PLANNING, ZONING, & BUILDING DEPARTMENT
PZ&B Staff Memorandum: Planning and Zoning Commission Meeting

SUBJECT: Breakers PUD Resolution and Standards for Approval

MEETING: March 6, 2025

Proposed New FEC

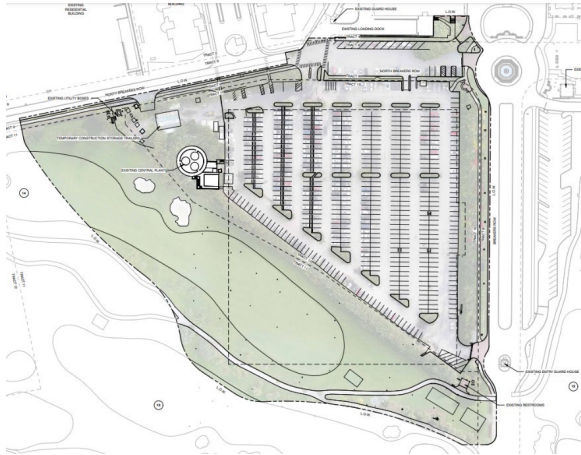
- (a) In a planned unit development, landscape treatment for plazas, roads, paths, service and parking areas shall be designed as an integral part of a coordinated landscape design for the entire project area. *As shown below, with the new FEC, the existing parking lot will be replaced with enhanced landscape treatment, an outdoor recreational area and elevated pedestrian connection to the Beach Club.*
